AIA Document G701™ – 2017

Change Order

PROJECT: (Name and address)
Williamson County
Animal Shelter Expansion
1855 SE Inner Loop
Georgetown, TX 78626

CHANGE ORDER INFORMATION:
Change Order Number: 003

A.3-5.42
Plot Date: 09/27/17

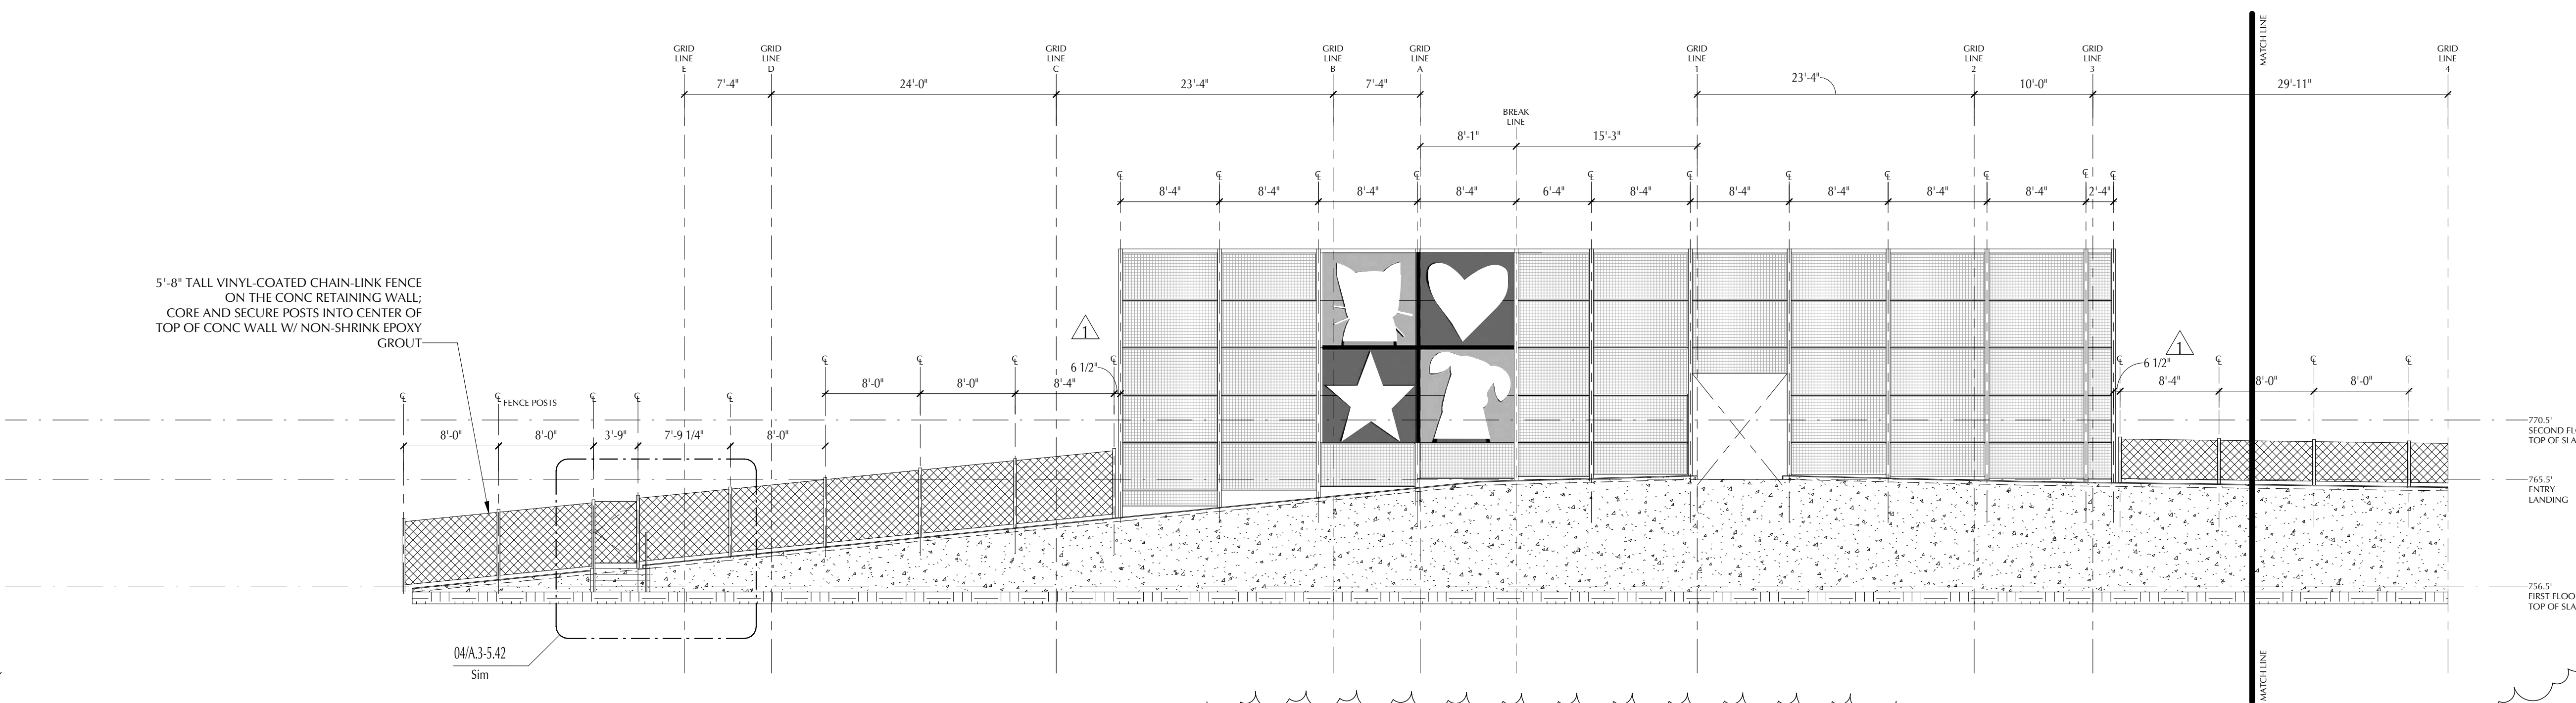
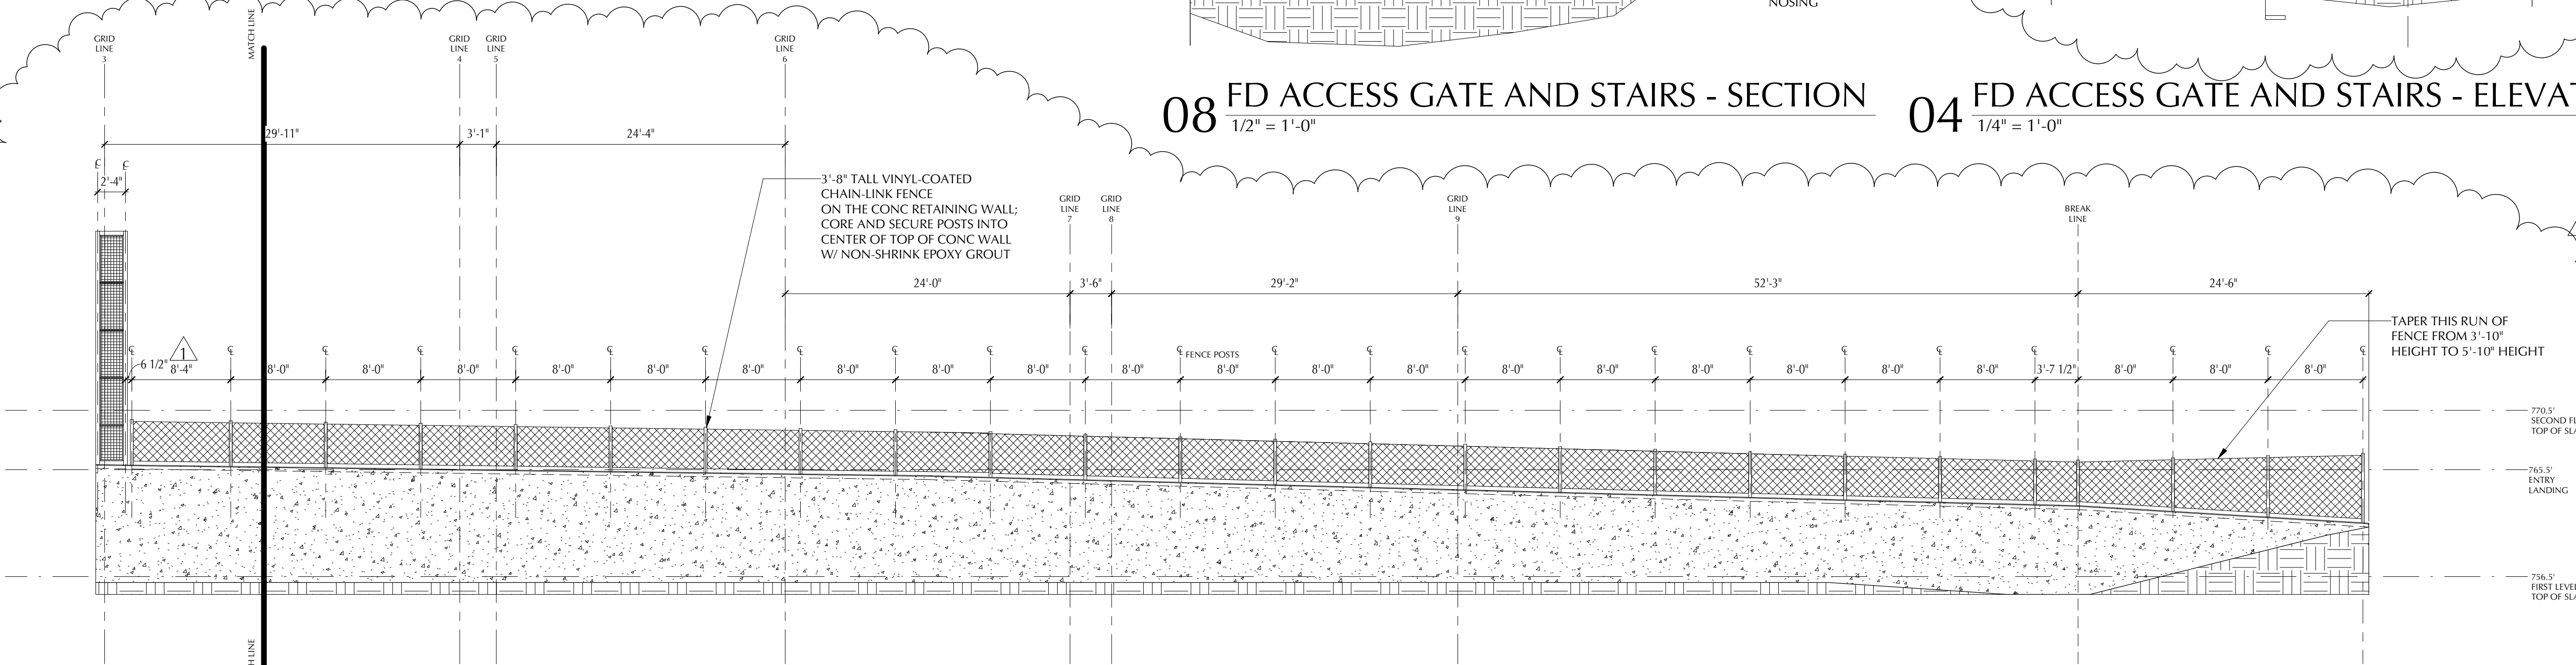
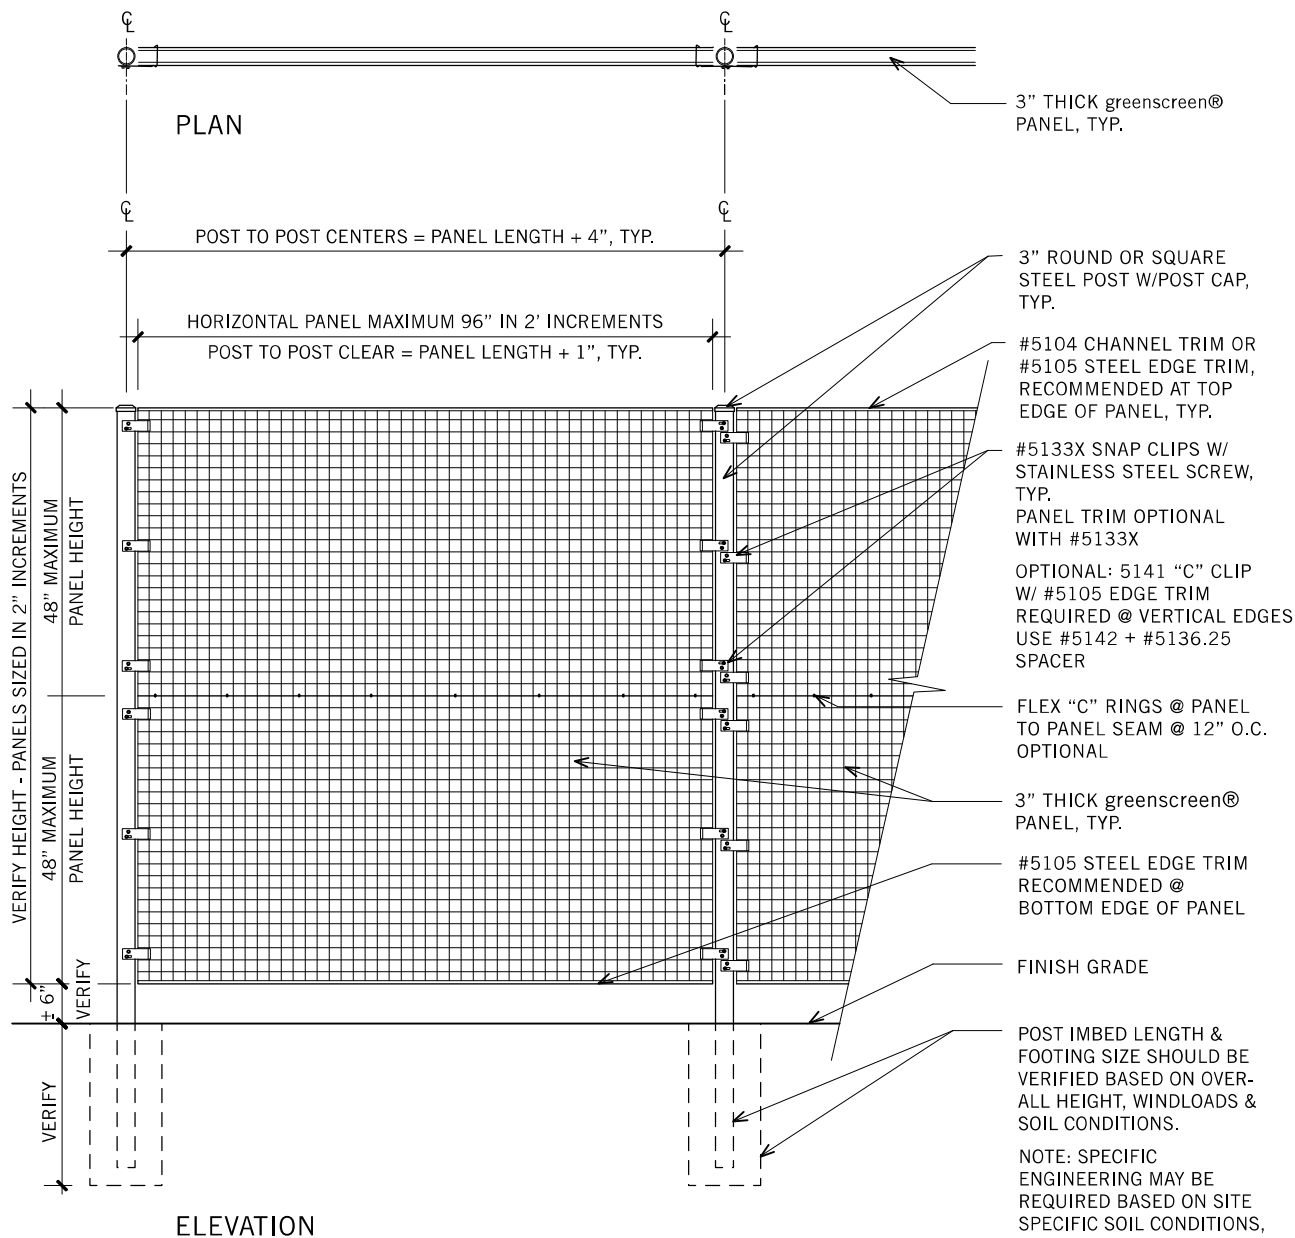
1) Reference detail 03 A.3-501 West Elevation- New adoption building and sheet S.3-2.03. The vertical columns on the structural differ from the elevation detail. Please advise if the structural is showing the correct columns and spacing or if the elevation is incorrect. If incorrect, please furnish correct elevation vie for Greenscreen.

2) Reference sheets S.3-2.03, A.3-5.40, A.3-5.42, A.3-5.41 and attached Greenscreen detail. Typical Greenscreen panels are 8 ft wide and require 1/2" clear space per side to accommodate the mounting brackets (see attached). With the 4" HSS columns, the 8'4" spacing from center of post to center will not be enough to install the panels as recommended. The spacing will need to be 8'5" center of column to column. Can the typical spacing for the columns be changed and the end sections at each run be reduced to accommodate this?

The greenscreen panels wrap around the top landing of the Public Entry, and have a west elevation at the east end of the Balcony canopy. See new elevation 12/A.3-5.41. The steel shown on this elevation is accounted-for in the Structural Framing shop drawings.

The spacing for the greenscreen support columns will remain as-drawn, and each panel can instead be reduced in width by 2". See revised drawing sheets A.3-5.41 and A.3-5.42 for updated screen wall and retaining all elevations which coordinate w/ the site grading on the approved Site Development drawings.

A.3-5.42

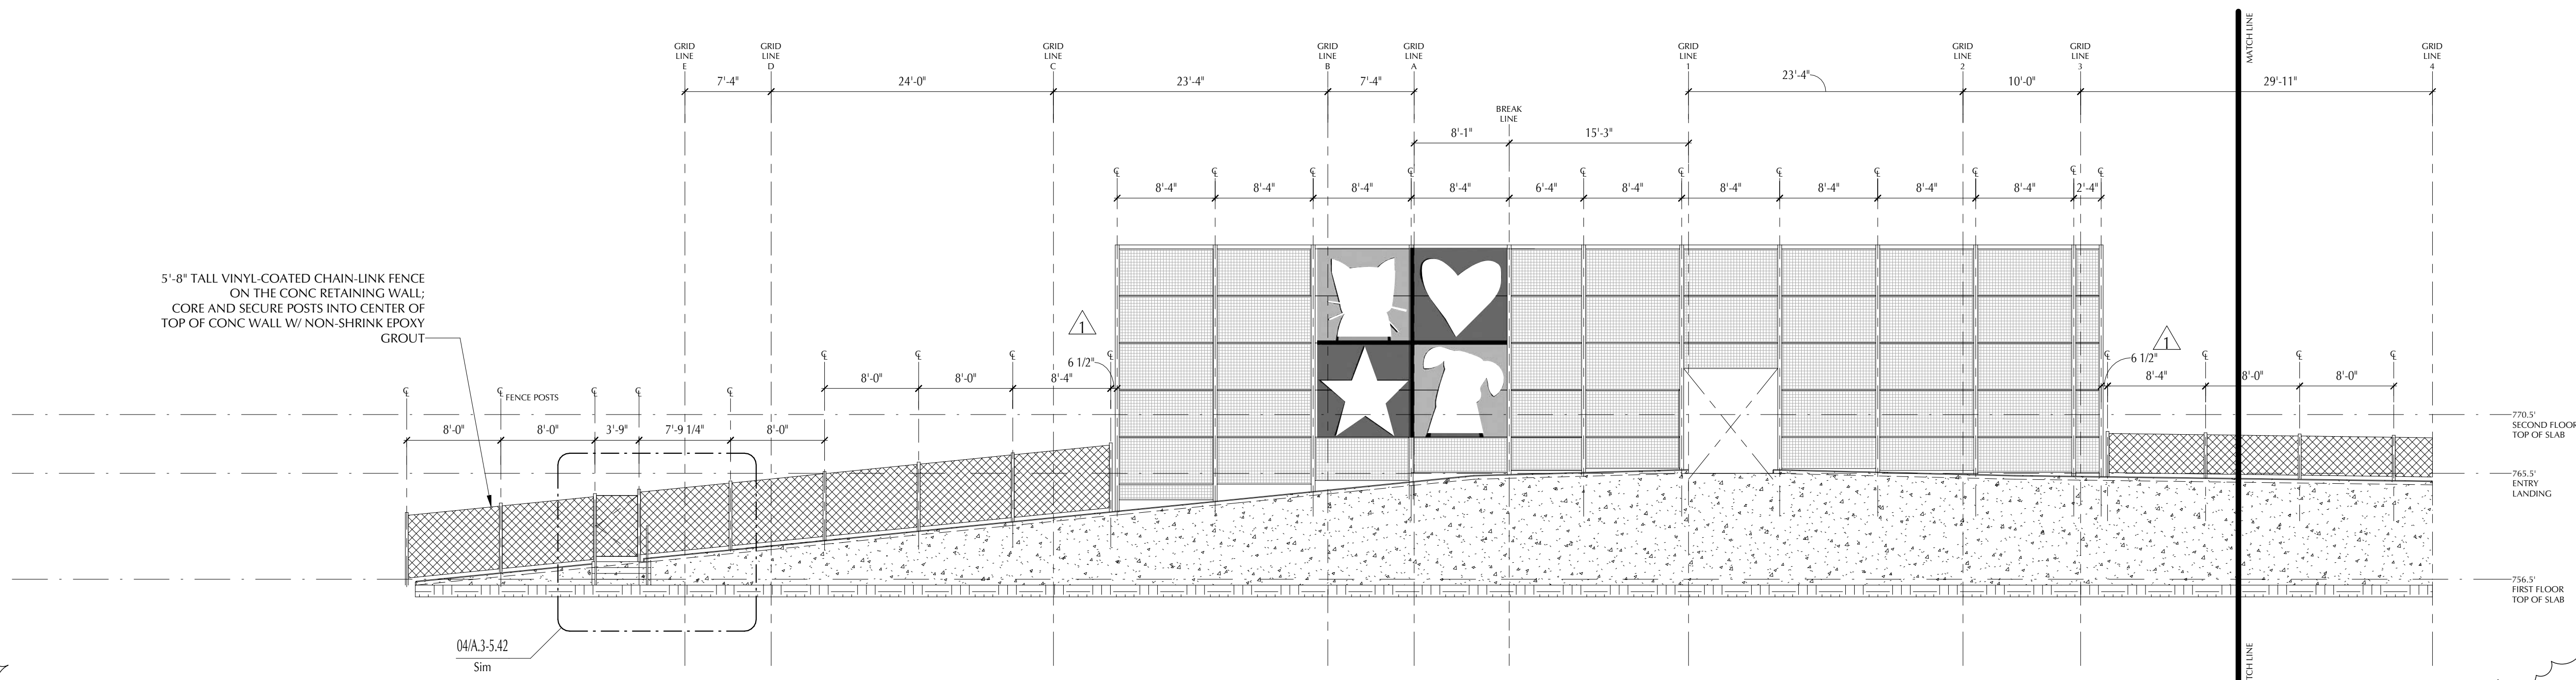
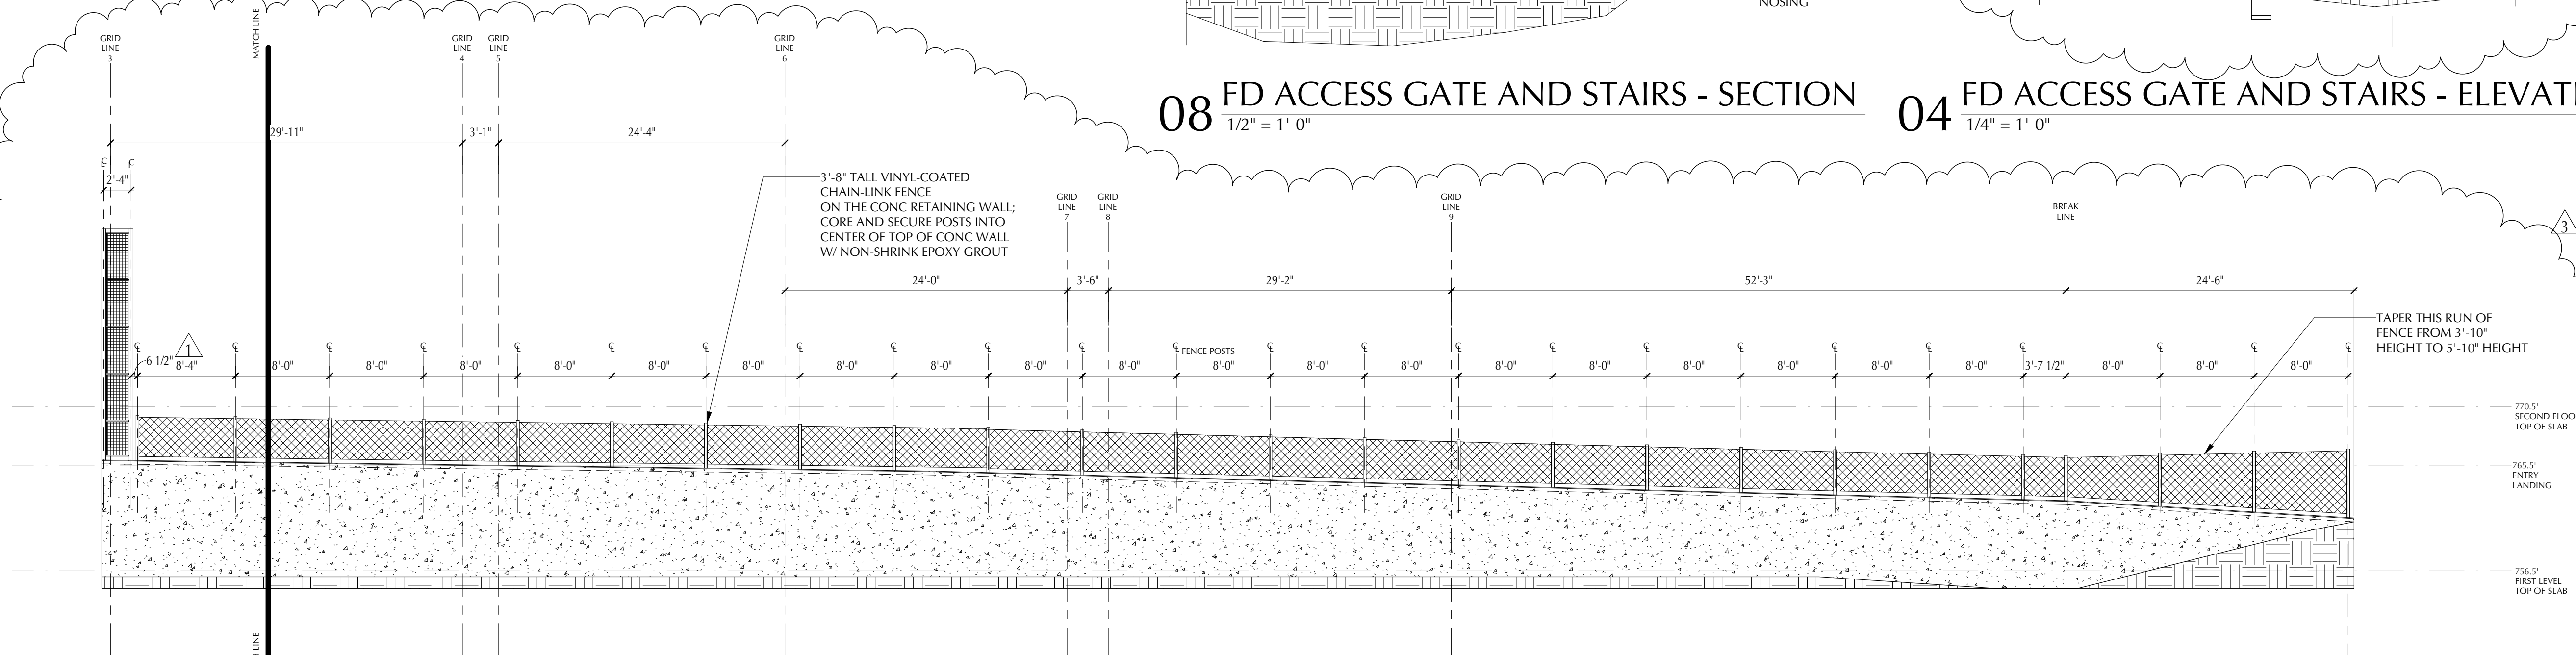
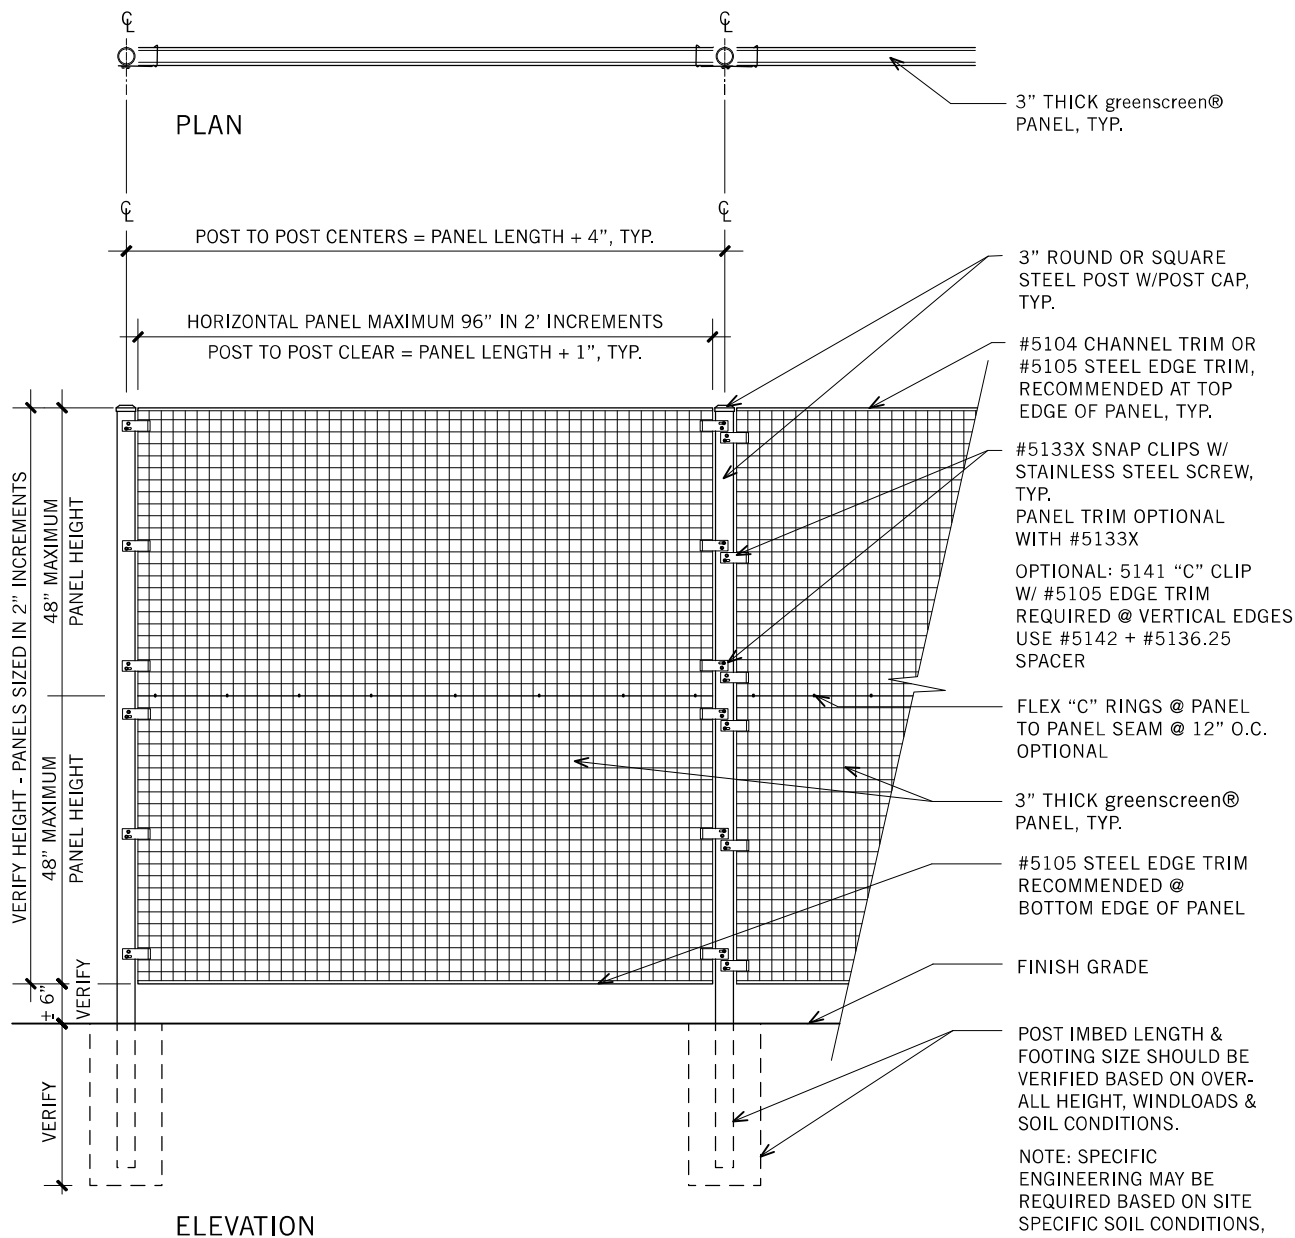
1) Reference detail 03 A.3-501 West Elevation- New adoption building and sheet S.3-2.03. The vertical columns on the structural differ from the elevation detail. Please advise if the structural is showing the correct columns and spacing or if the elevation is incorrect. If incorrect, please furnish correct elevation vie for Greenscreen.

2) Reference sheets S.3-2.03, A.3-5.40, A.3-5.42, A.3-5.41 and attached Greenscreen detail. Typical Greenscreen panels are 8 ft wide and require 1/2" clear space per side to accommodate the mounting brackets (see attached). With the 4" HSS columns, the 8'4" spacing from center of post to center will not be enough to install the panels as recommended. The spacing will need to be 8'5" center of column to column. Can the typical spacing for the columns be changed and the end sections at each run be reduced to accommodate this?

The greenscreen panels wrap around the top landing of the Public Entry, and have a west elevation at the east end of the Balcony canopy. See new elevation 12/A.3-5.41. The steel shown on this elevation is accounted-for in the Structural Framing shop drawings.

The spacing for the greenscreen support columns will remain as-drawn, and each panel can instead be reduced in width by 2". See revised drawing sheets A.3-5.41 and A.3-5.42 for updated screen wall and retaining all elevations which coordinate w/ the site grading on the approved Site Development drawings.
